Mask Set Errata for Mask 4L47P

This mask set errata applies to the mask 4L47P for these products:

- MC68HC908AP64A
- MC68HC908AP32A
- MC68HC908AP16A
- MC68HC908AP8A

Figure 1. Typical ADC Error Count

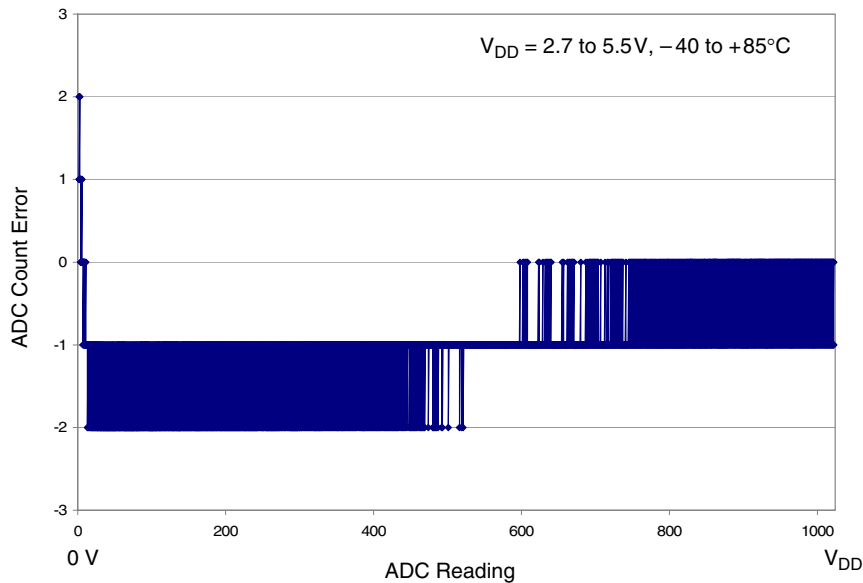
The 10-bit ADC conversion result for 0V input (zero input reading) is \$000, \$001, \$002, or \$003; not the specified \$00 or \$01. With inputs of 5mV and above, the ADC is within the specified accuracy of ± 1.5 LSB (see [Figure 1](#)).
